**Johnston County Public Schools  
HVAC CONTROLS REPLACEMENTS – PACKAGE 6**

**ADDENDUM NO. 2**

**DATE:** December 14, 2023

**PROJECT:** Johnston County Public Schools  
Controls Replacements – Package 6

PROJECT NO. 50159407-P6  
**2ME-204**  
 SHEET NO. OF

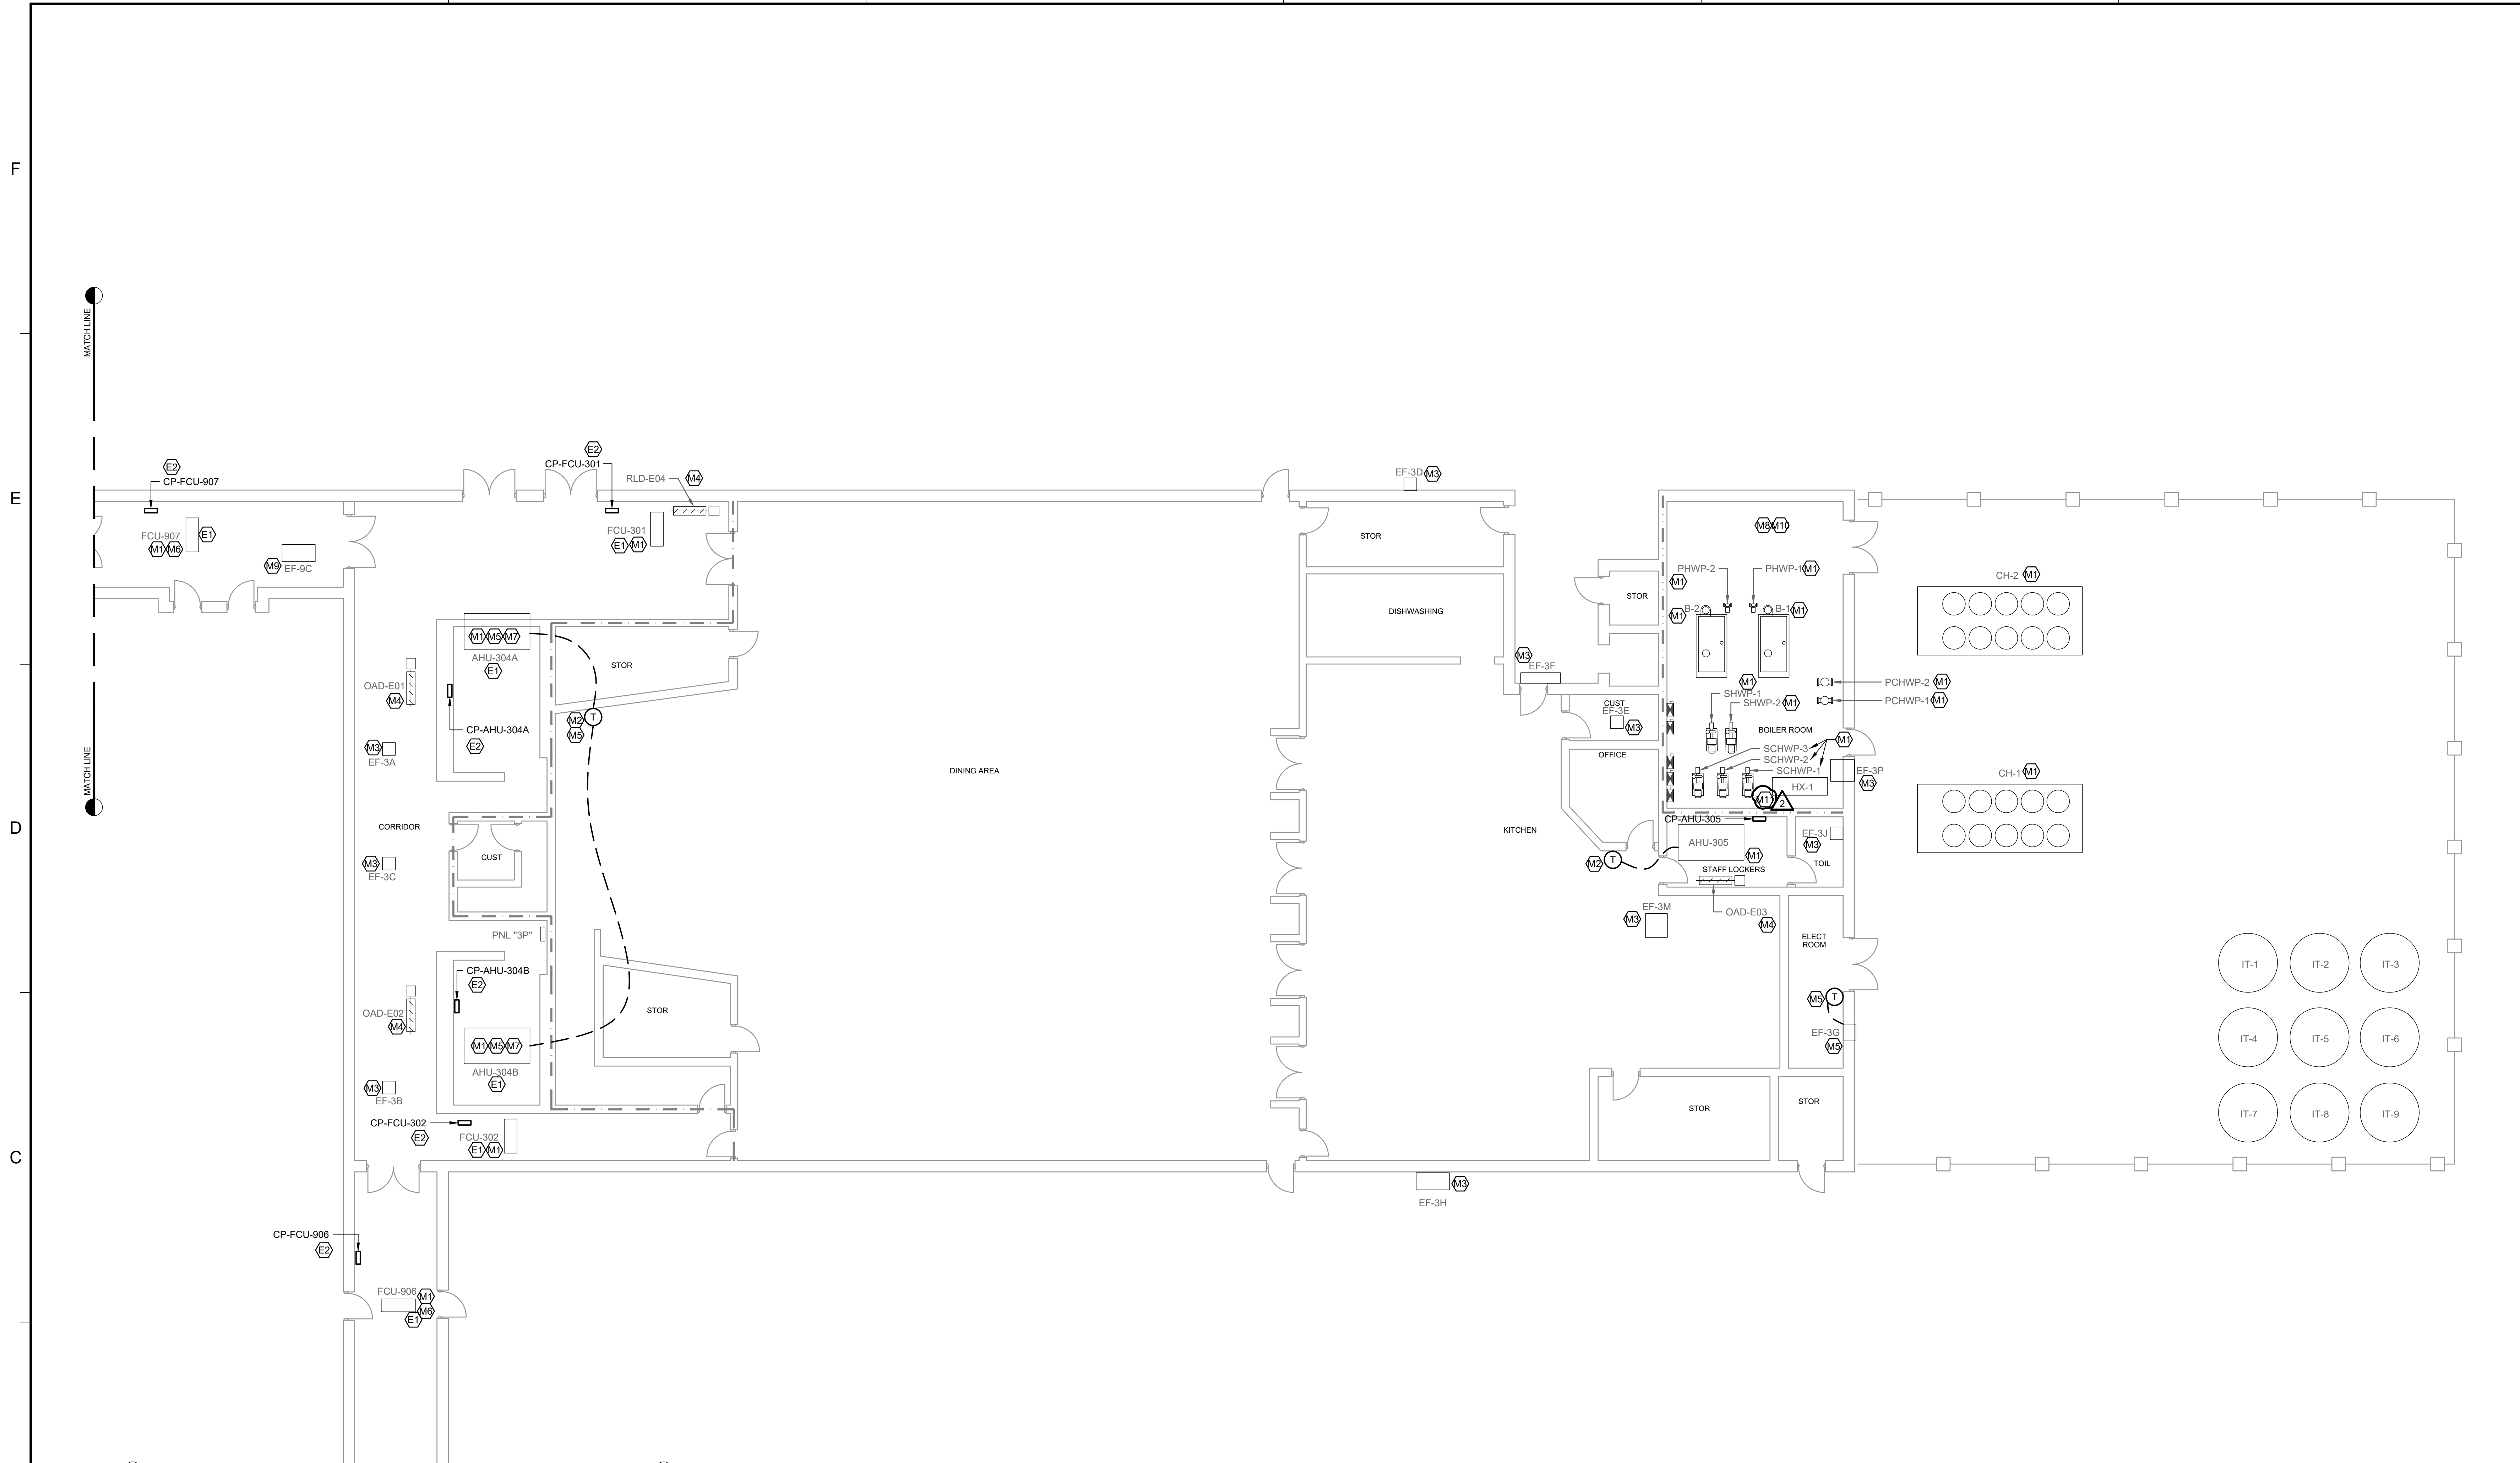
9. Sheet 2ME-201 – Keynote removed. Thermostats combined for FCU-130 and AHU-103.
10. Sheet 2ME-204 – Keynote removed.
11. Sheet 2ME-205 – Keynote removed.

TITLE: RIVERWOOD MS AREA A

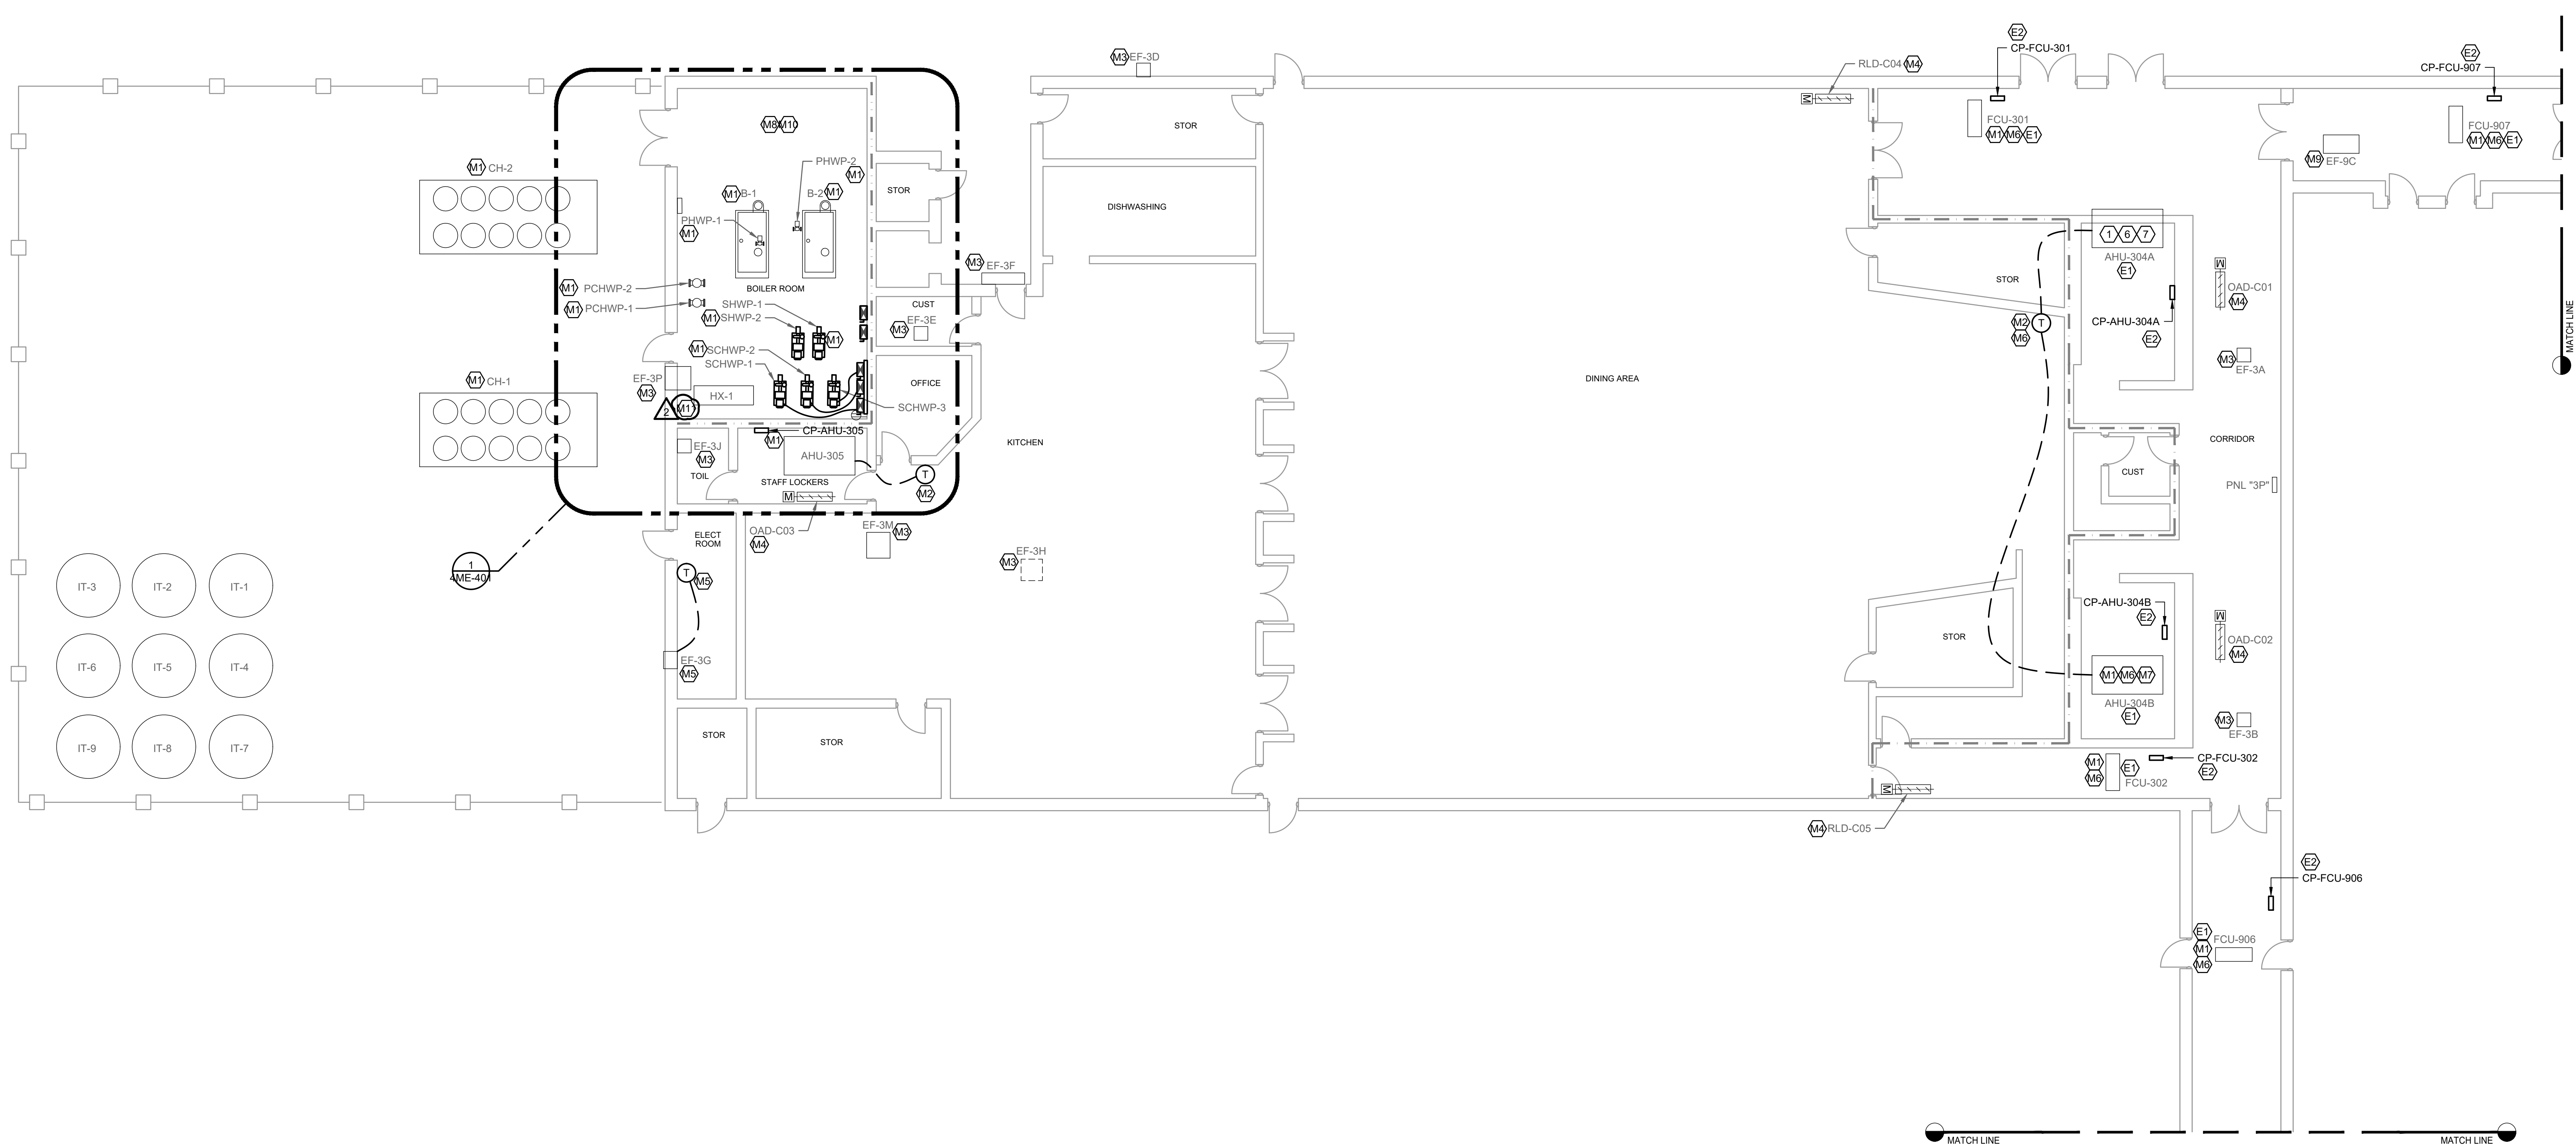
15. Sheet 3M-601 – Air System schedules adjusted.
16. Sheet 3M-602 – Flowmeter schedule adjusted.
17. Sheet 4ME-201 – Thermostats combined for FCU-130 and AHU-103.

**TITLE**  
RIVERWOOD MS  
AREA C

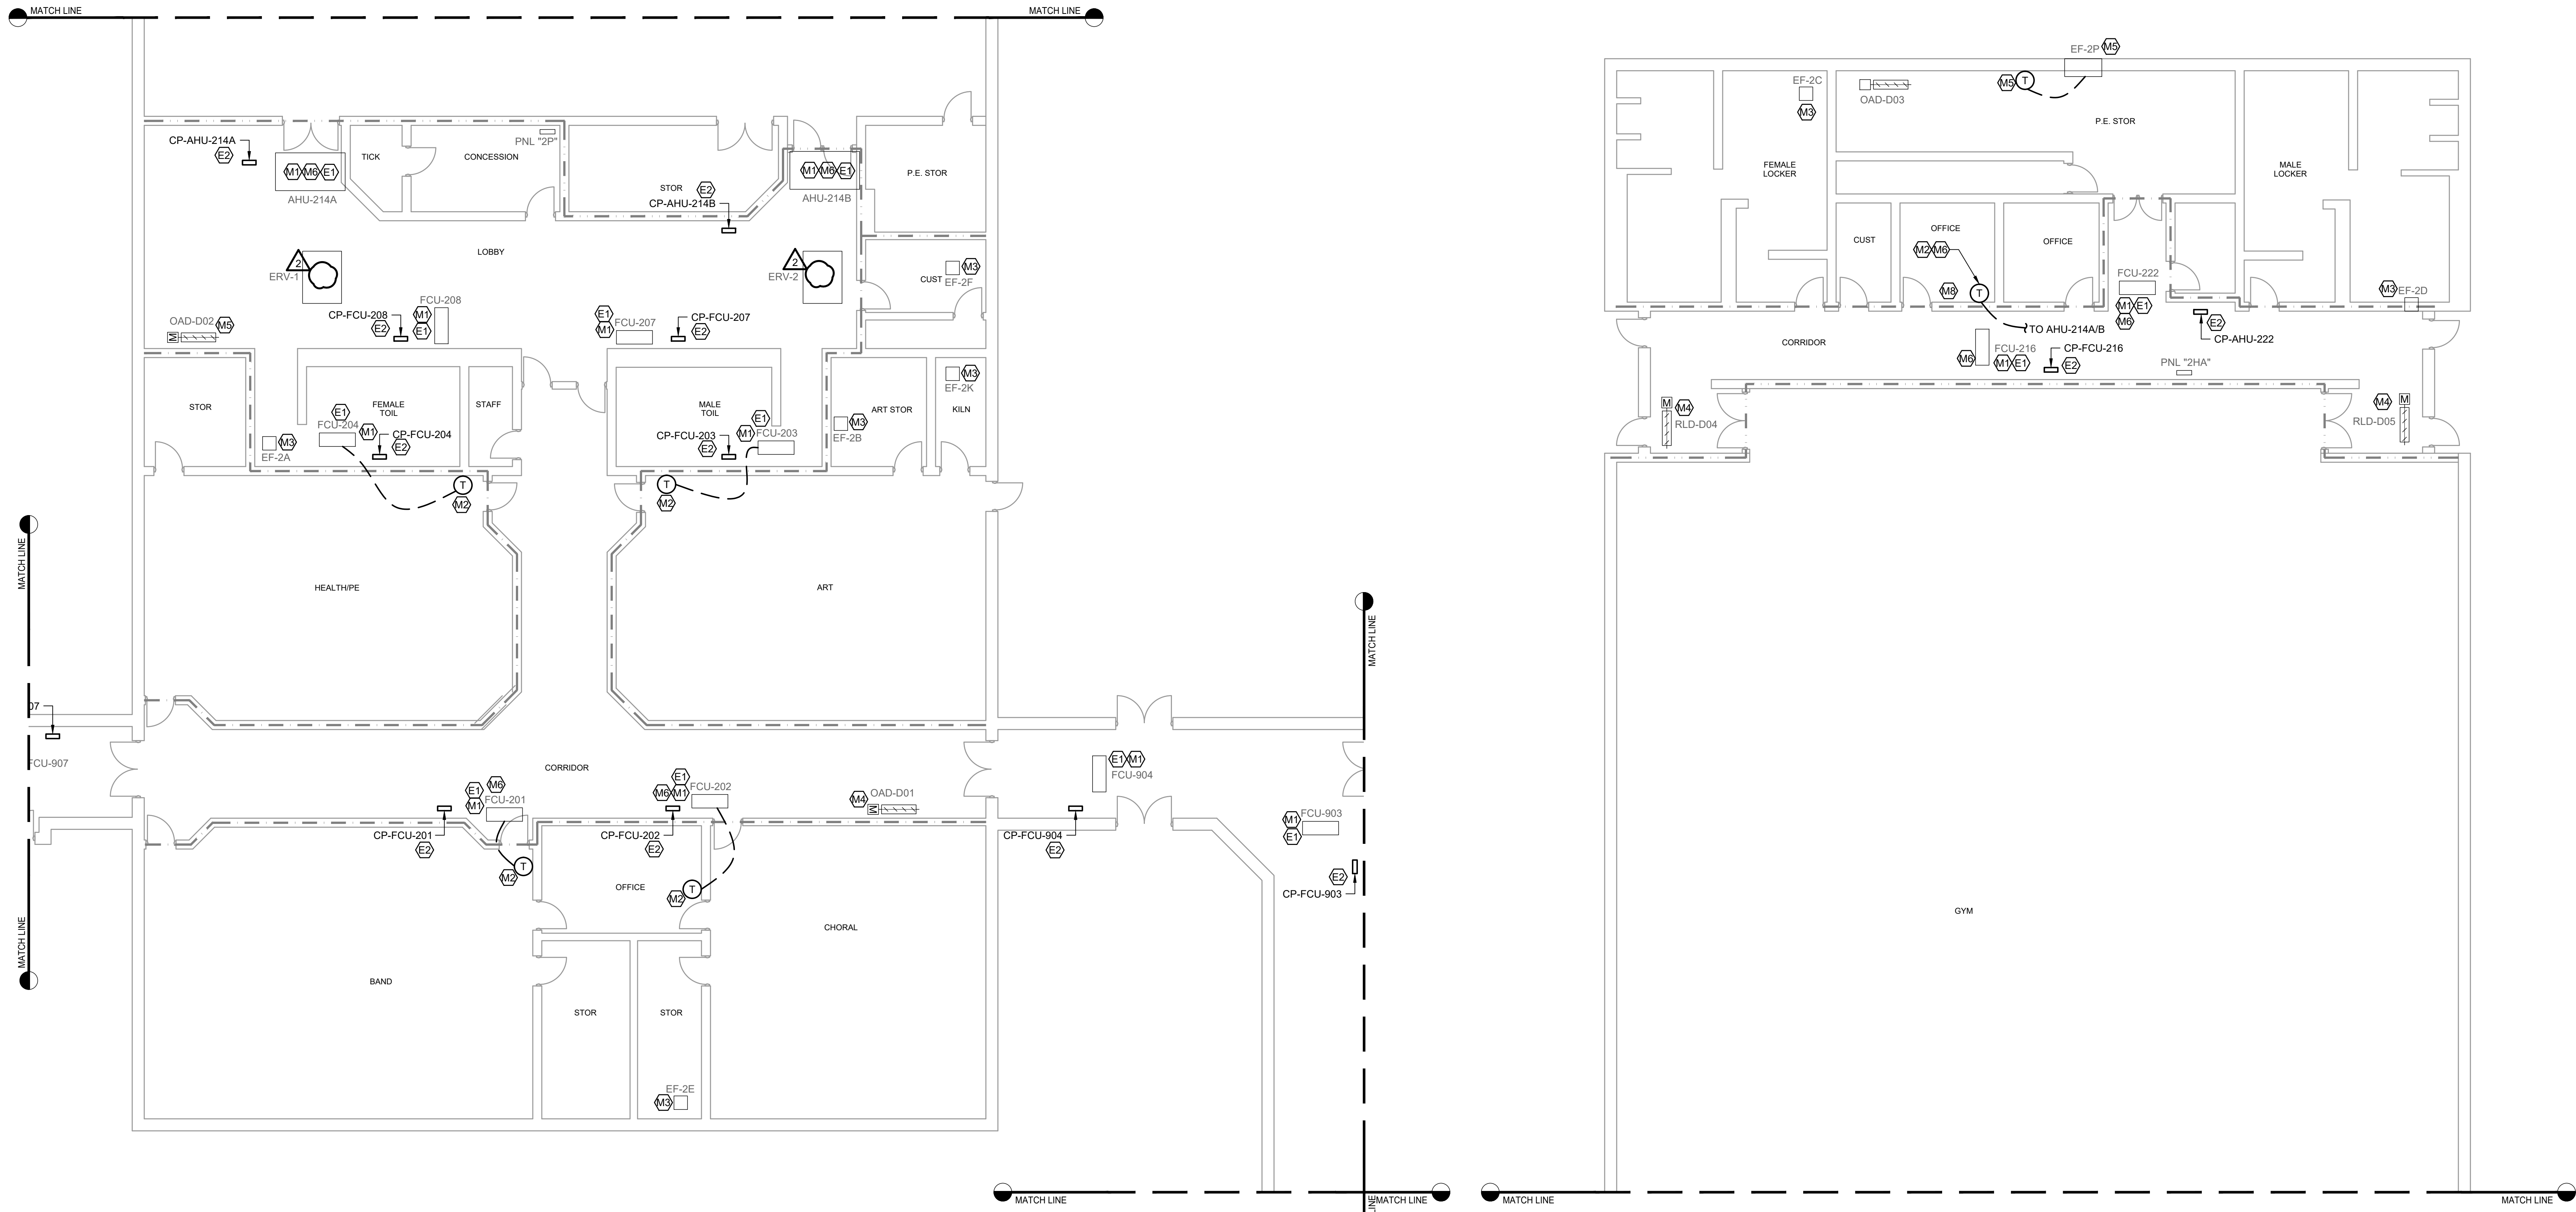
18. Sheet 4ME-203 – Keynote removed.
19. Sheet 4ME-204 – Keynote removed.
20. Sheet 4ME-206 – Thermostat moved and note added.
21. Sheet 4M-601 – Air System schedule adjusted.
